Title: Advisory Committee on Reactor Safeguards
 Plant License Renewal Subcommittee

Date: September 23, 2015

PLANT LICENSE RENEWAL SUBCOMMITTEE
 DAVIS-BESSE NUCLEAR POWER STATION

Shield Building Exterior Elevation IR Test Data
Data through 24 July 2012

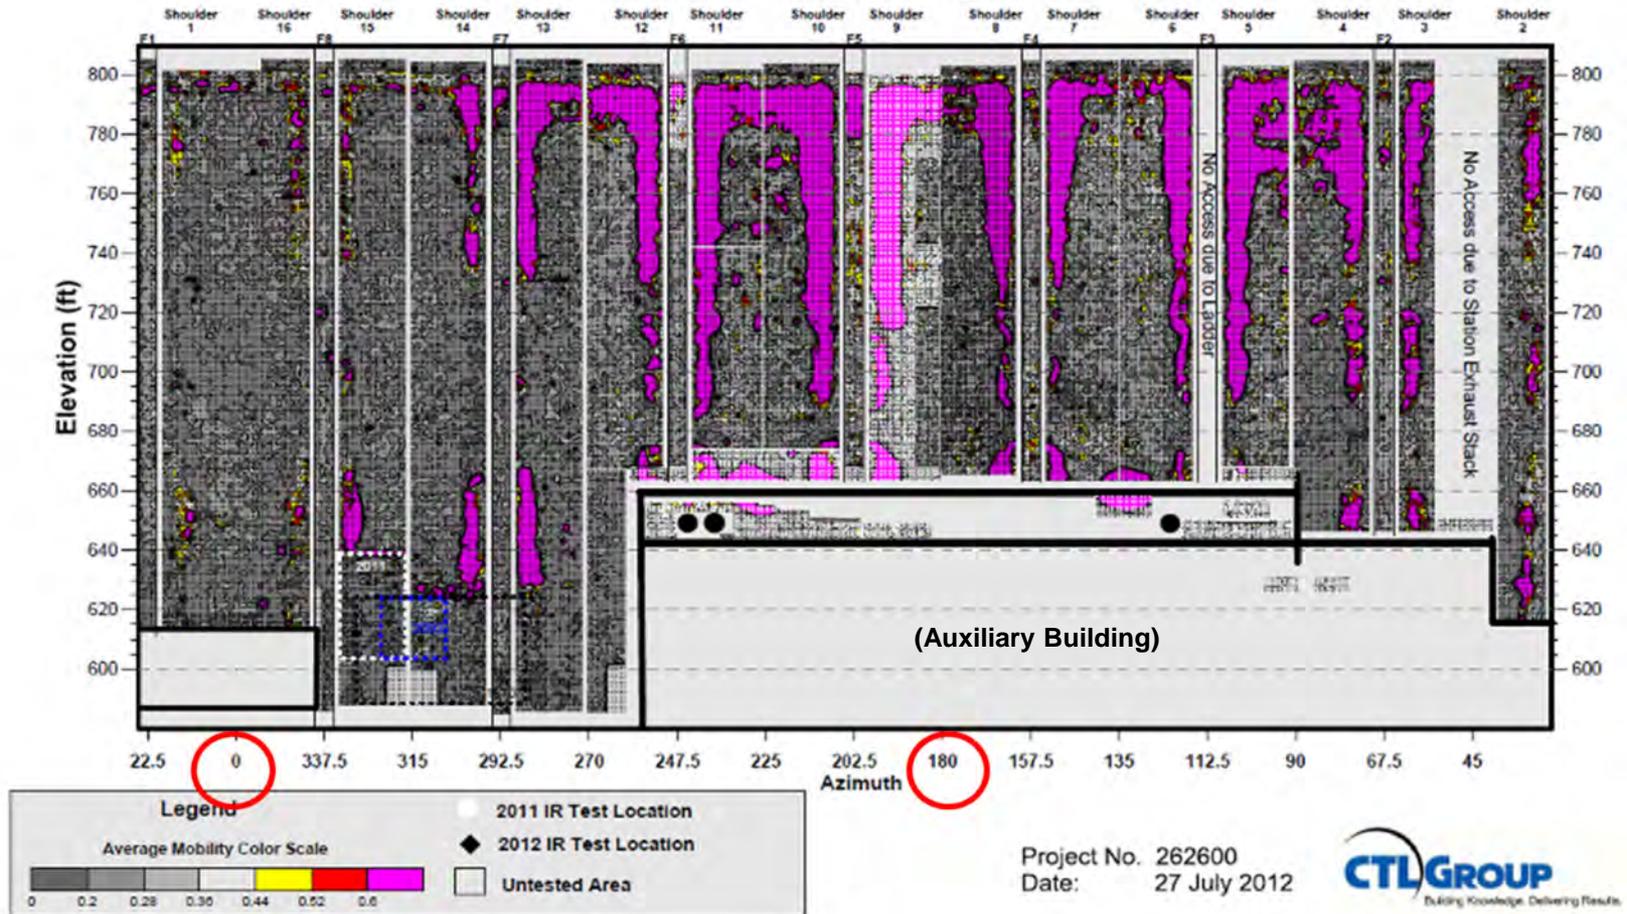
9 So, this is an impulse response layout
10 map of the exterior portions of the shield
11 building. The magenta areas are portions of the
12 building where the impulse response testing
13 indicate we have laminar cracks.

19 MR. SHACK: While you've got this
20 figure up, the other, you know, you've got your 23
21 bores, three of which are at the leading edge, can
22 you point out to me on this figure roughly where
23 those bores are?

5 And, as I say, if I look at the radial
6 stress figure, I've got a little tiny region
7 surrounded in a sea of green. It doesn't really
8 seem to explain much of the extent of the -- when I
9 look at the pink area, it's hard to match up with
10 that thing.

1 CHAIRMAN RAY: Well, I'm sorry, I
2 didn't mean to interrupt you, but in the picture we
3 show, you know, there's such a large irregular area
4 affected in some cases on the south side that it's
5 hard to imagine that everything is captured by that
6 rebar cage that we're -- if you want to call it
7 that.

14 To answer your question regarding the
15 three leading edge bores, I can use the drawing
16 here, Mr. Dort, if you can point to shoulder five
17 right above the aux building.

Long Term Monitoring

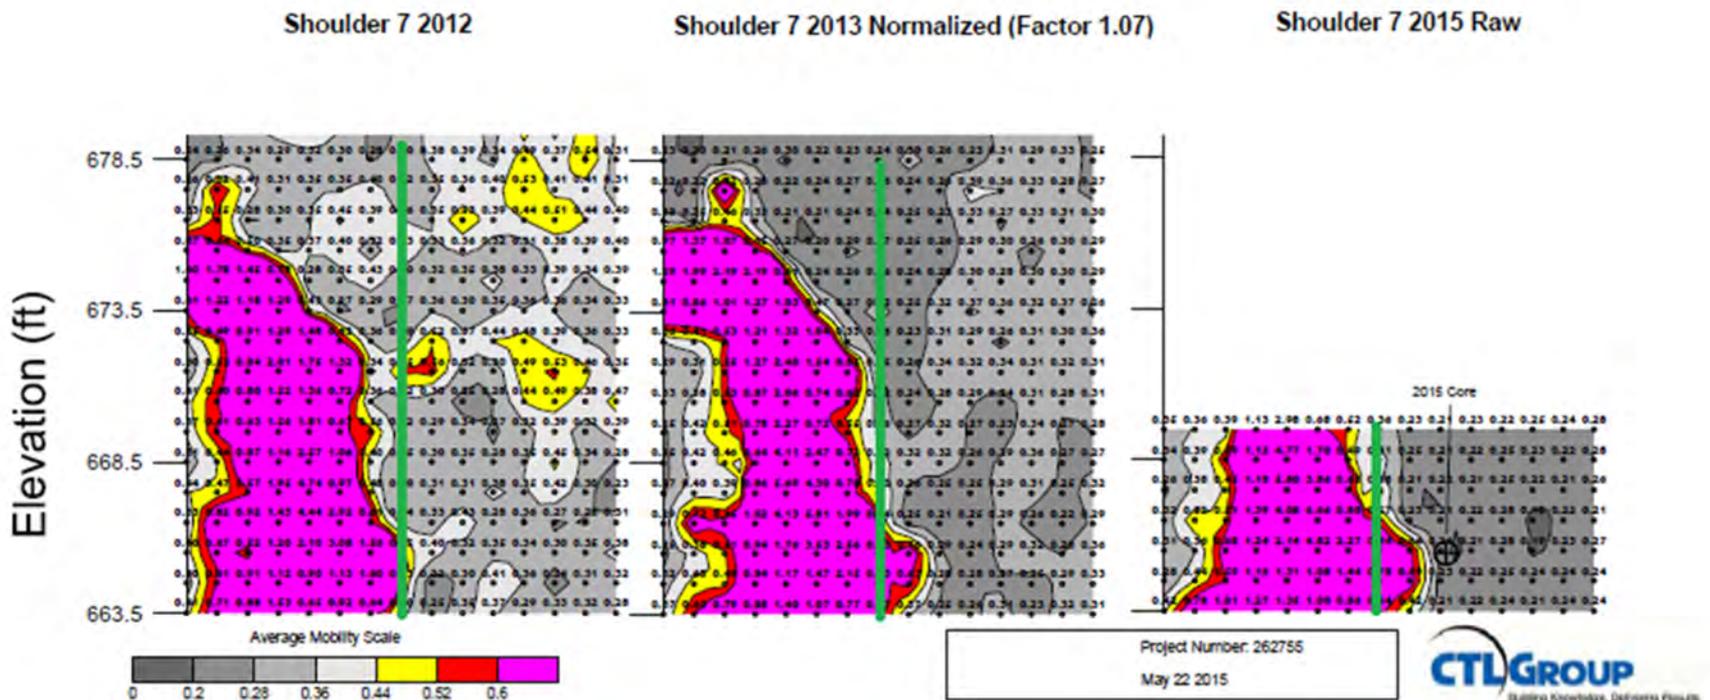
2 MEMBER SCHULTZ: The first bullet,
3 identified changes in eight of the 80 core bores
4 inspected. Can you describe what is the change and
5 what constitutes the identification of a change and
6 how that's --

1 Regarding -- our Aging Management Program defines
2 any discernable change in the core bore get entered
3 into our Corrective Action Program.

4 For the definition of that discernable
5 change, if you were looking at shoulder seven, we
6 had a series of bores that were drilled in that
7 shoulder. We saw propagation from one bore that
8 was cracked to a bore that was not cracked.

9 So, we conducted a bore scope
10 inspection down that hole and saw a crack in an
11 area where we had not previously had not previously
12 seen a crack. So, that would be a discernable
13 change that we did identify and led us into this
14 causal investigation.

15 If I may continue to address one
16 previous question that was asked? As far as the
17 leading edge cracking, if you actually take a look
18 on shoulder seven on the right hand map, you'll see
19 the 2015 bore that was installed in that location
20 and that is our new leading edge tracking bore for
21 shoulder seven.

**SHIELD BUILDING - EXTERIOR DEVELOPED ELEVATION
 WITH TABLE 1 - REQUIRED BORE INSPECTION LOCATIONS PAGE 35 EN-DP-01511**

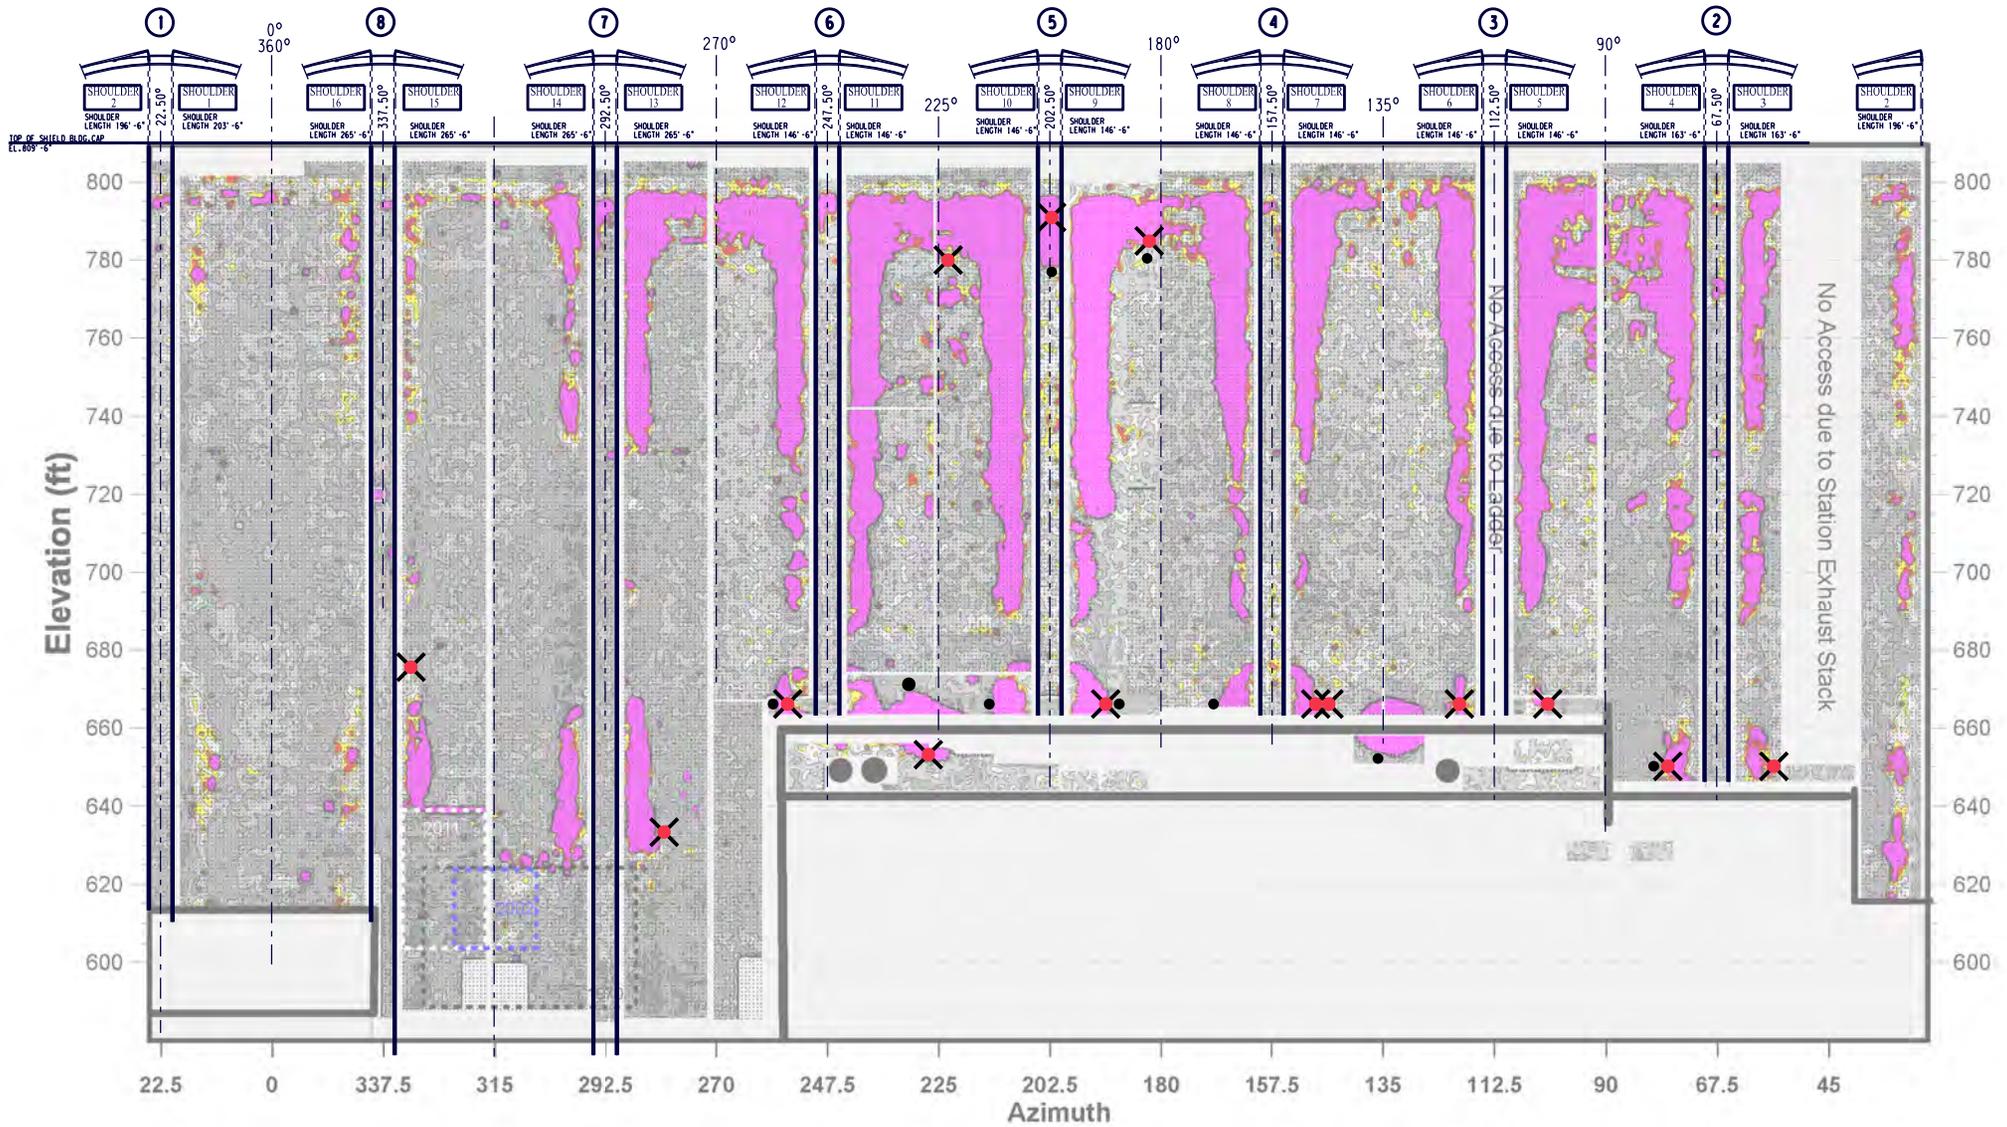
17 MEMBER CORRADINI: Okay, I think of
18 that as the answer. So why not hit them with the
19 hammer there so that you have a backup monitoring
20 that is more complete.

2 MR. HENRY: I'm Thomas Henry. I'm just
3 going to enhance that answer by stating that the
4 shoulders that we talked about earlier with 5, 7,
5 13 and the 15, where we added additional leading
6 edge bores, the leading edge bores are actually not
7 shown on this drawing. These are the 23 that we've
8 committed to as part of our program. The leading
9 edges are supplemental on top of that, so there are
10 additional uncracked bores on those shoulders that
11 you don't see in that drawing.

8 MR. HENRY: Around shoulder 9, around
9 the center of the drawing, there are bores that are
10 in the top 20 foot area that we talk about.
